City of Phoenix
PLANNING & DEVELOPMENT DEPARTMENT

Staff Report Z-SP-3-18-7
September 7, 2018

Request From: [C-2 BAOD](#) (10.27 acres)
Request To: [C-2 SP BAOD](#) (10.27 acres)
Proposed Use Special permit to allow self-service storage, household moving center (truck rental), and all underlying C-2 uses

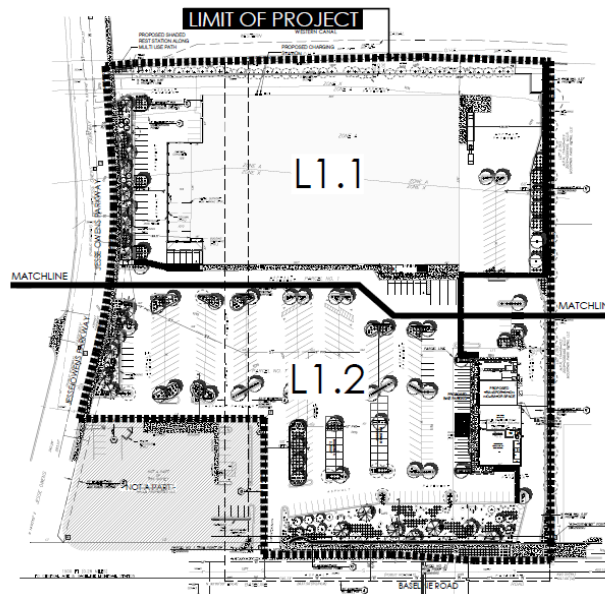
Staff does not recommend general conformance to the Overall Site Plan (see attached) submitted with the request. The subject site was permitted and developed prior to the adoption of the Baseline Area Overlay District and there are numerous features depicted on the site plan, reflecting the existing development, which would not comply with the current requirements of the requested C-2 SP BAOD zoning designation. These features include, but are not limited to the following:

- The site plan does not include shaded and raised walkways within the parking lot, which is a required design guideline of the BAOD (651.E.2.a).
- The site plan does not propose overhangs a minimum of 10 feet in width along all pedestrian walkways adjacent to buildings, which is a required design guideline of the BAOD (651.E.2.c).

Site improvements and/or redevelopment of the site will require the developer to bring the site into compliance with requirements of the Baseline Area Overlay District. However, these requirements may vary depending on the city's proportionality policies. The policy establishes guidelines for incremental

improvements of existing commercial developments. Therefore, staff stipulations individually address particular areas of concern including BAOD requirements regarding the Baseline Road landscape setback, pedestrian walkways, parking lot landscaping, and landscaping in the project's main entry. See Background Item Nos. 8-12 for detailed discussion regarding these stipulations.

Conceptual Elevations
 Source: Amerco Real Estate Company

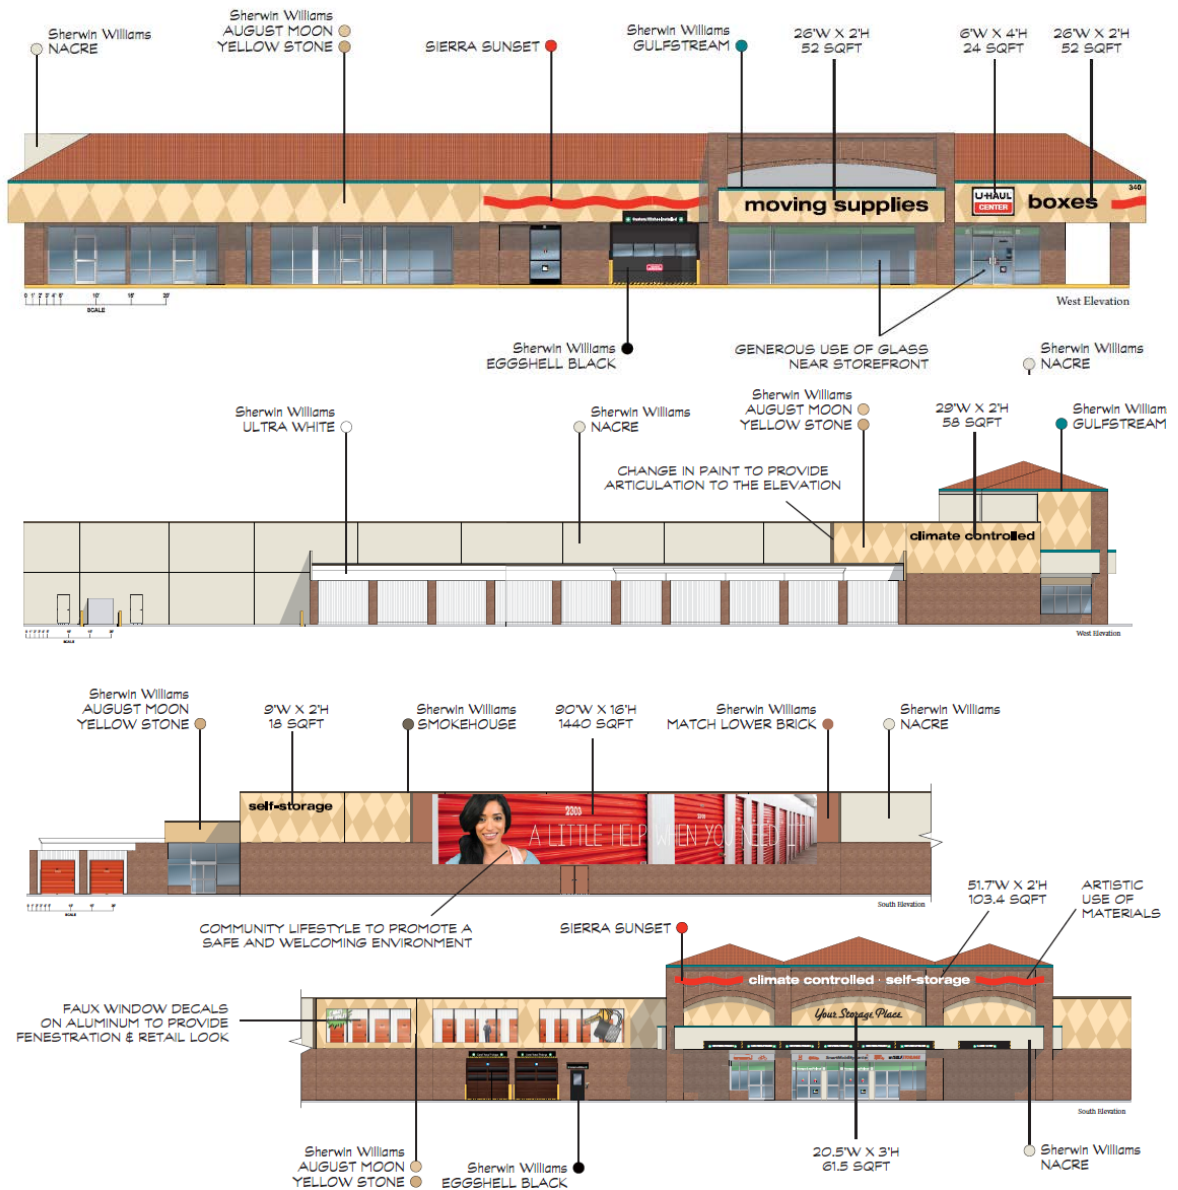
The applicant is proposing to redesign the exterior facades of existing buildings to include multiple paint colors, graphic signs, and architectural accent features.

Staff does not recommend general conformance to the proposed elevations as they do not exceed the Guidelines for Design Review as outlined in Section 507. Tab A of the Zoning Ordinance.

Staff does recommend a requirement that all building elevations, including those facing or visible from the Western Canal, shall contain multiple exterior accent materials, architectural embellishments, and/or detailing such as green screens, textural changes, pilasters, offsets, recesses, variation in window size and location, and/or other overhang canopies. Providing these additional architectural elements will create visual interest for the site and help to mitigate the impacts of the building massing, particularly along the Western Canal. This is addressed in Stipulation No. 4.

STORAGE ELEVATION / CONCEPTUAL IMAGING

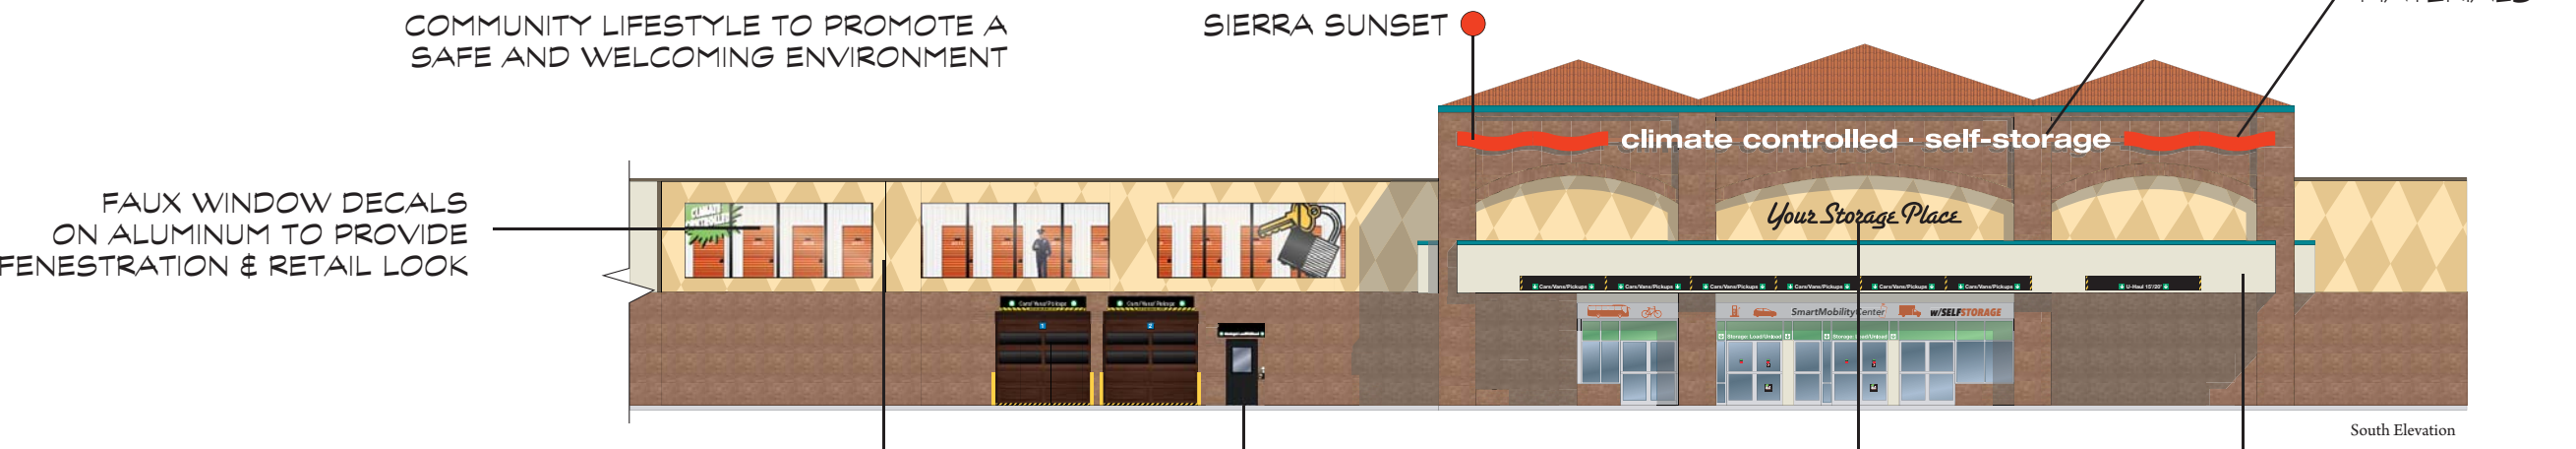
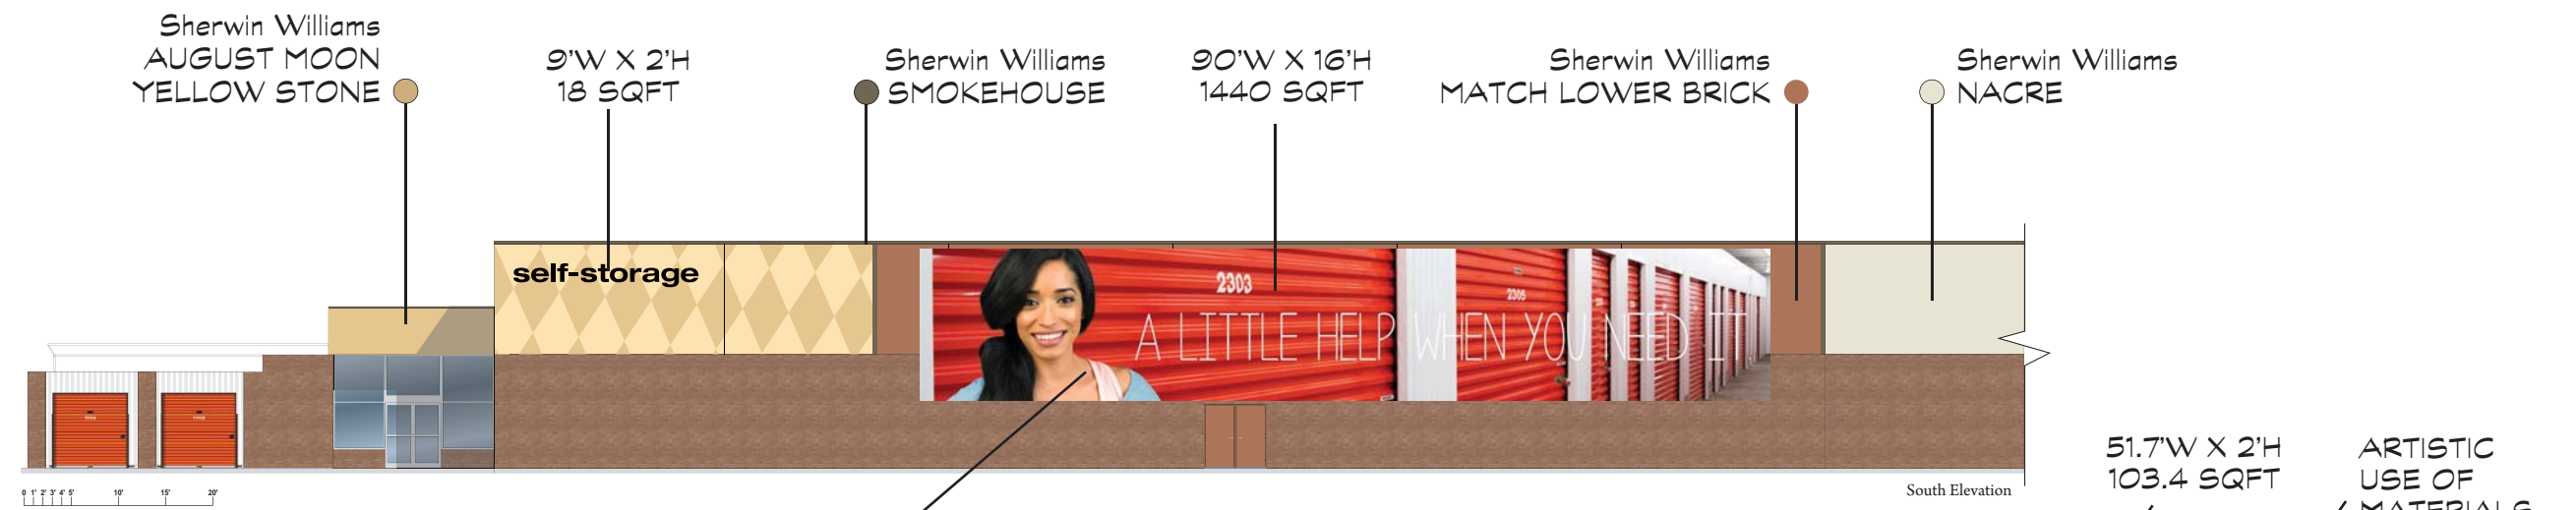
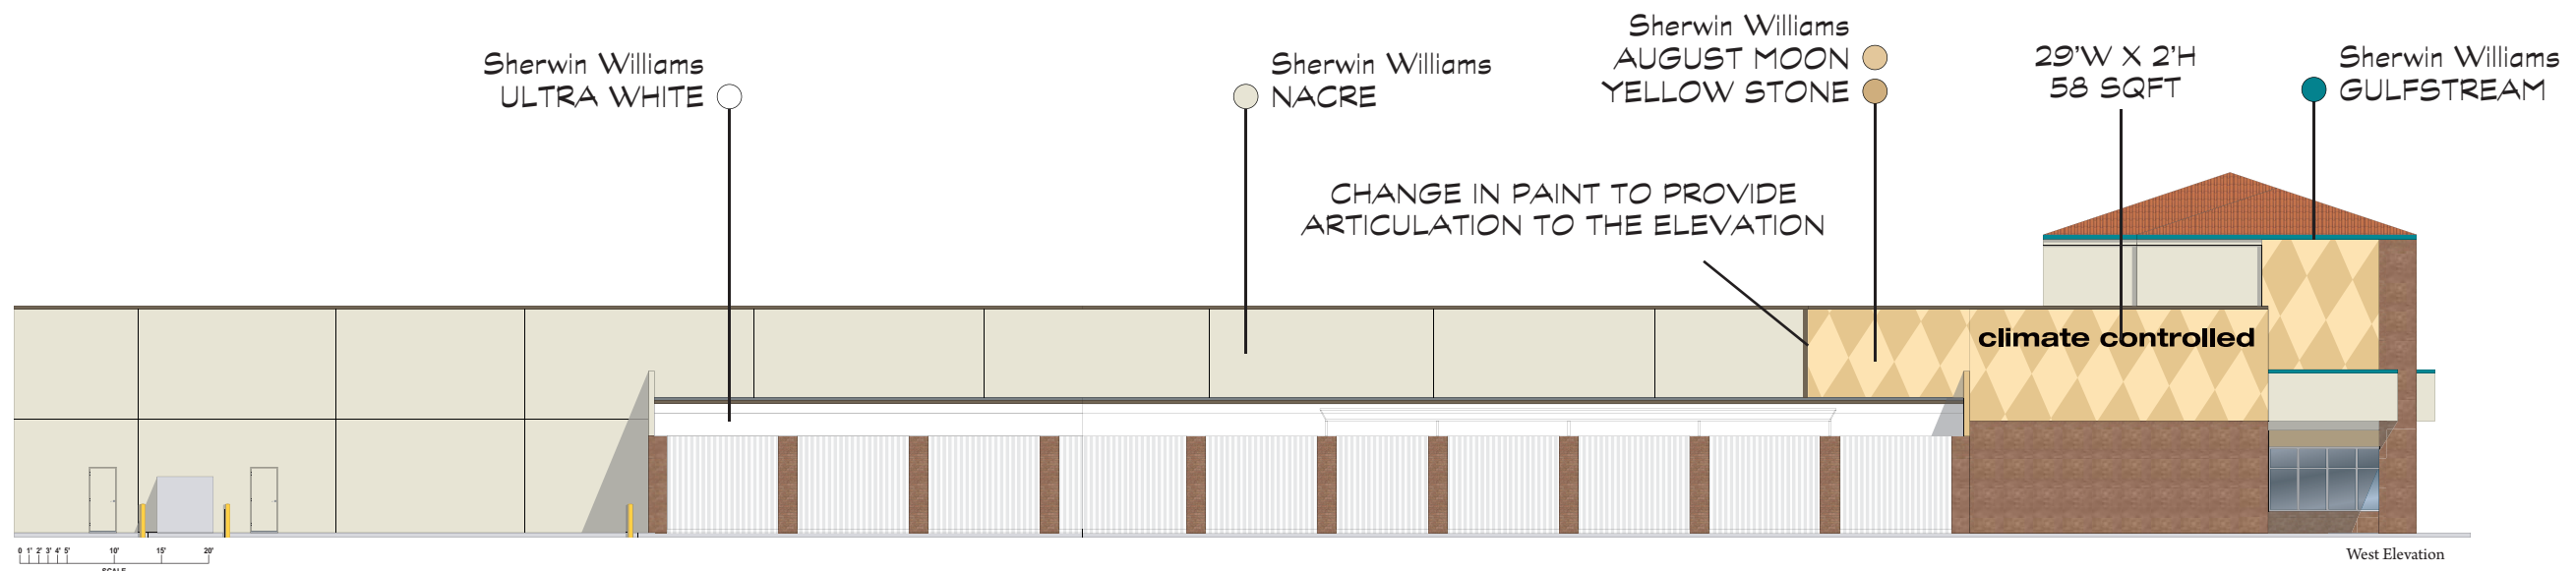
No conceptual elevations were provided for the two proposed buildings self-service storage unit buildings along the southern perimeter of the site. The applicant indicated to staff that these buildings would include roll-up bay doors which provide direct access to the interior of the units. The Overall Site Plan also does not indicate any screening of these buildings by walls, landscaping, or other means.

Staff recommends a stipulation requiring that no bay doors be visible from any public rights-of-way. This stipulation is intended to avoid adverse visual impacts on the Baseline Road corridor. The BAOD applies similar screening restrictions to drive-through restaurants along Baseline Road. Stipulation No. 1 regarding improved landscaping and Stipulation No. 14 regarding a multi-use trail, both along Baseline Road, are intended to promote a visually appealing streetscape along this scenic corridor. The restriction regarding bay doors is addressed in Stipulation No. 6.

6. No bay or loading doors shall be visible from public rights-of-way, as approved by the Planning and Development Department.
7. The developer shall provide a landscaped entry area along Baseline Road that shall be a minimum of 1,000 square feet in area and be planted and maintained with a variety of at least three plant materials including a series of annuals that will each maintain a constant bloom throughout the year, as approved by the Planning and Development Department.

CONCEPTUAL
 AMENITIES PLAN
 08/01/2018

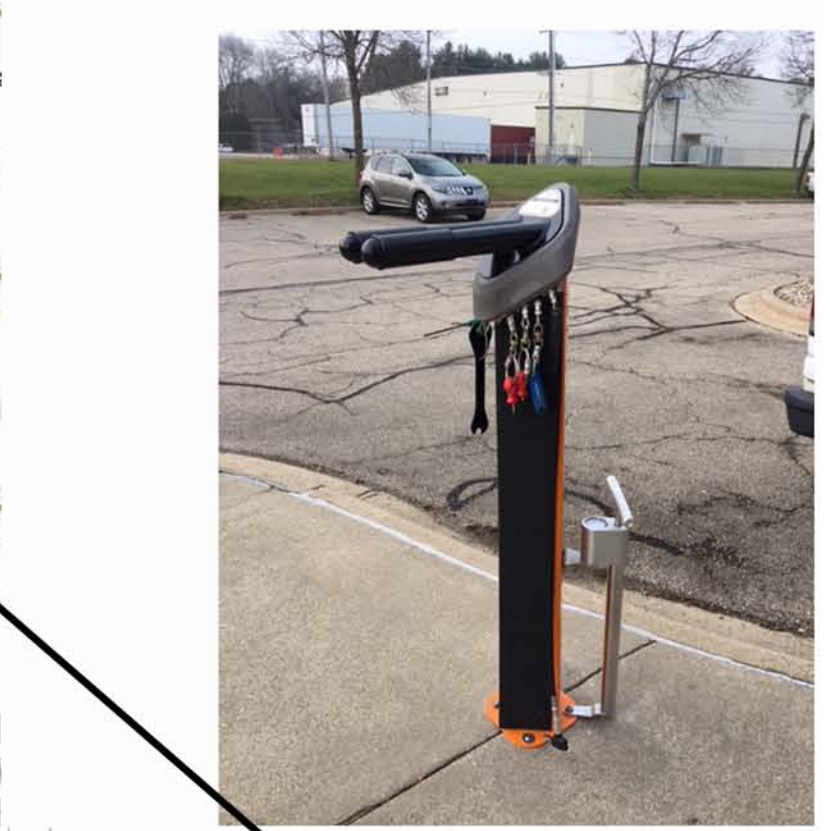
1. It is my understanding that the city has requested Uhaul to create a “gathering” space at the Northwest end of their property, where it adjoins the canal. By doing this it would eliminate the direct access from the rear of their building onto Jesse Owen Parkway. I am not in agreement with this stipulation. My first concern is that the proposed “gathering” area would not add any value to the customers using this type of business and would be out of place. I think it also creates an area for people to congregate and may make it unsafe for residents who currently use the canal as a walking/jogging path. The fact that constructing this “gathering” area also would require traffic to redirect south into the parking lot does not make any sense to me. We are talking about people who are renting large moving trucks, who are not professional drivers and we are asking them to make several turns into a parking lot with cross traffic. To me this appears to be a safety hazard. I thought one of the great advantages of this application, at this site was the direct access from the building onto Jesse Owens Parkway, which is a lightly traveled street.

2. I believe that it was also requested of Uhaul to install a horse corral area to the Northeast of the property? I am at a complete loss as to why this would be a request for this property. This makes absolutely no sense to me and I cannot see any reason that this would have even been suggested. I cannot envision these ever being utilized.

- d. Bicycle repair station as depicted on the Conceptual Amenities Plan date stamped August 1, 2018 and/or as approved by the Planning and Development Department.
